RICHMOND UPON THAMES LOCAL PLAN
Publication consultation on the Council's final version of the Plan and final SA report
(Regulation 19)
RESPONSE FROM THE OLD DEER PARK WORKING GROUP

Response from the Old Deer Park Working Group, dated 31 July 2023 (extension granted by Richmond upon Thames Council ref email from [REDACTED] to Peter Willan dated 20 July 2023)

OLD DEER PARK WORKING GROUP

Kew Character Areas (G1 ODP), Urban Design Study Dec 2021

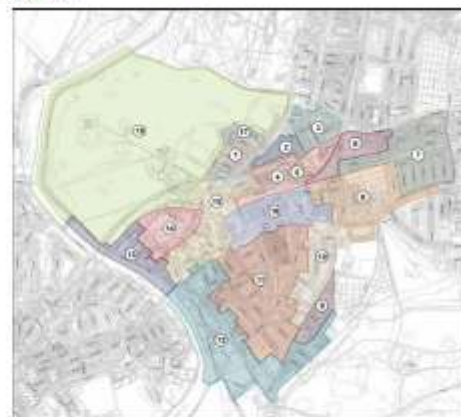
Place Definitions. Based on Section 3 – Character Areas in Arup’s 432-page Urban Design Study, The Old Deer Park is incorrectly grouped with the Royal Botanic Gardens, Kew in Character Area ‘G1 – Kew Gardens and Riverside’ under the overall heading ‘G –Kew’. Like Richmond Park, the Old Deer Park should be covered by its own Character Area as ‘F4 – The Old Deer Park’, under the overall heading of ‘F – Richmond & Richmond Hill (sic)’. On this basis, other sections of Arup’s Urban Design Study and to the Draft Local Plan need to be adjusted accordingly.

Indeed, more fundamentally, the proposed structure of ‘Character Areas’ as set out in Section 3 et seq. in Arup’s Urban Design Study needs to be challenged. The proposed boundaries relate neither to the present Ward boundaries nor to the existing conservation area boundaries. They should surely be based for the most part on the present conservation areas and in this case the Old Deer Park Conservation Area.

We have extracted the Character Area Map from Arup’s Urban Design Study Dec 2021 and provided a Conservation Area Map so that members of the community reading our response can better understand the context.

See response to Comment 618 regarding the character area boundaries.

Kew Character Areas (G1 ODP). Urban design Study Dec 2021

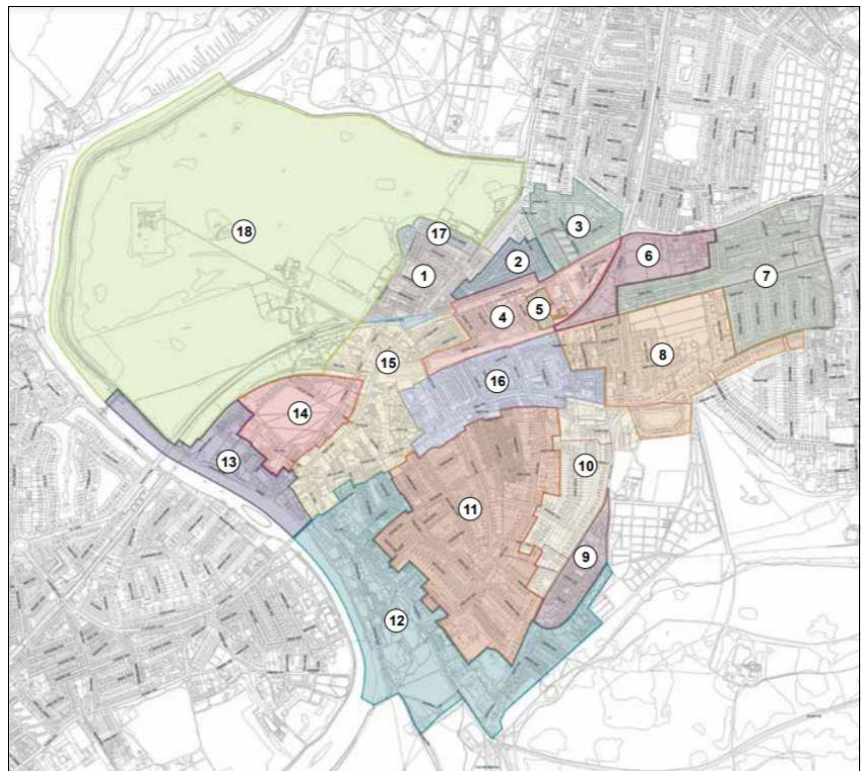
1. **Place Definitions.** Based on Section 3 – Character Areas in Arup's 432-page Urban Design Study, The Old Deer Park is incorrectly grouped with the Royal Botanic Gardens, Kew in Character Area 'G1 – Kew Gardens and Riverside' under the overall heading 'G –Kew'). Like Richmond Park, the Old Deer Park should be covered by its own Character Area as 'F4 – The Old Deer Park', under the overall heading of 'F – Richmond & Richmond Hill (sic)'. On this basis, other sections of Arup's Urban Design Study and to the Draft Local Plan need to be adjusted accordingly.

4. We have extracted the Character Area Map from Arup's Urban Design Study Dec 2021 and provided a Conservation Area Map so that members of the community reading our response can better understand the context.

Figure 2 Extract from Local Views Map July 2022 for consultation

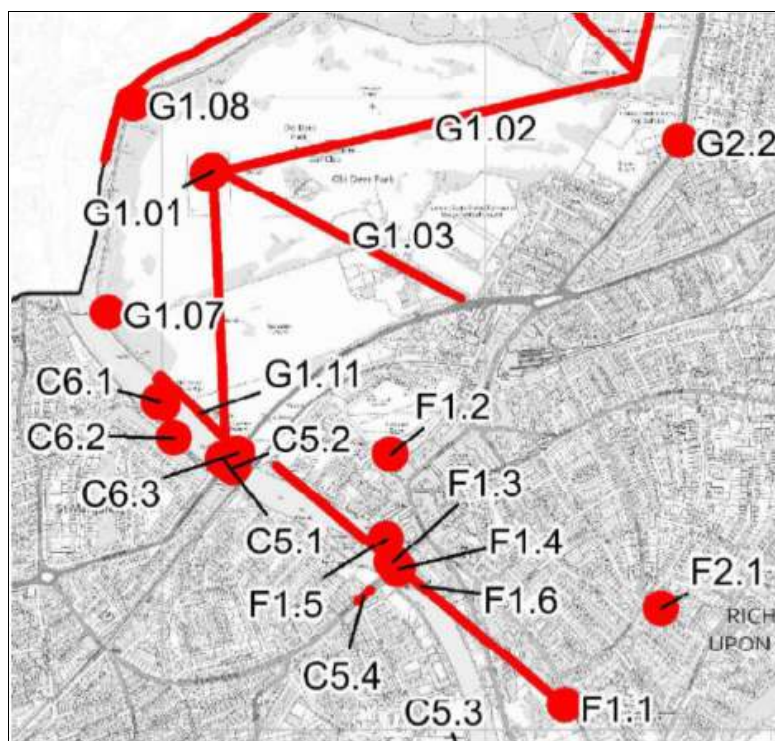
- d. Local Views map
 - i. Detail in the map is insufficient to be able to identify viewing locations and specific view end points (often the end points can be guessed at but not for all of the views).

- ii. It would seem the map shows all four linear views relevant to the ODPG with a line. The map is busy with views and it would help to distinguish the views by having directional arrows on the lines and an arrow for each of the non-linear views.

Figure 11 ODP Landscape Views and Open Space. Source ODP SPD 2018

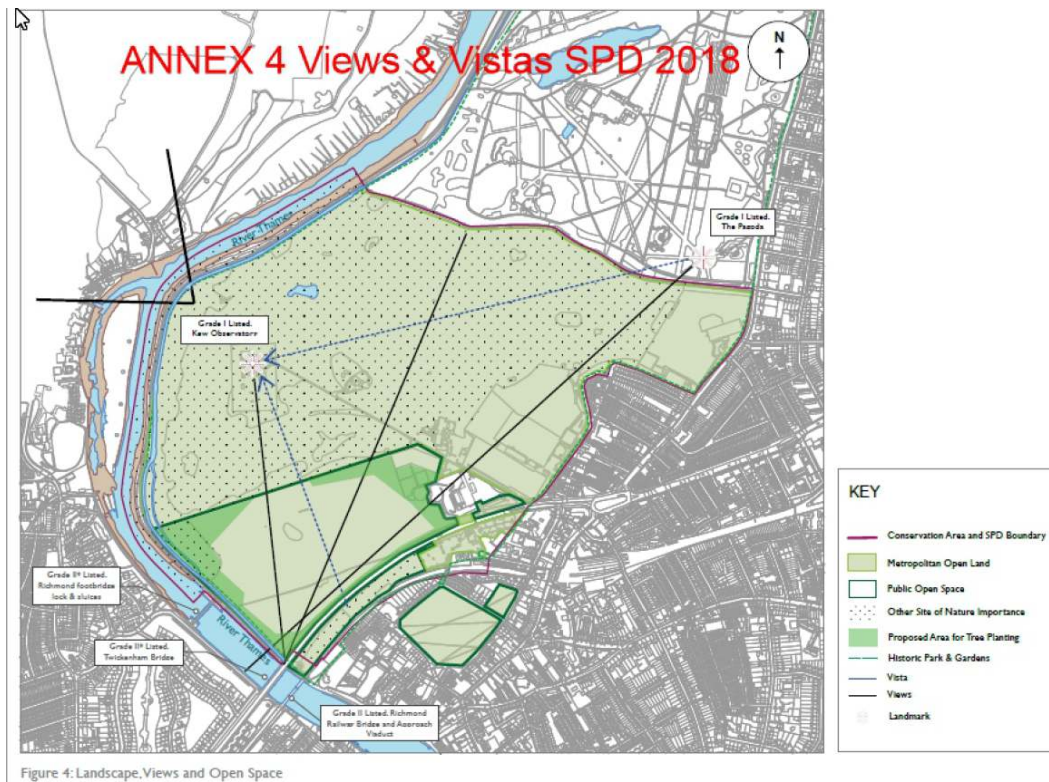
The Crown Estate Strategy for the Old Deer Park proposes a number of linear views from the King's Observatory. One has already been adopted G1.1 *King's Observatory to stone obelisks*. Two are proposed by the SPD G1.2 *King's Observatory towards Kew Gardens* and G1.3 *King's Observatory towards Richmond Town Centre*. But from the Crown Estate map others should be considered. The Old Deer Park SPD 2018 replicated some of these, see Figure 11.
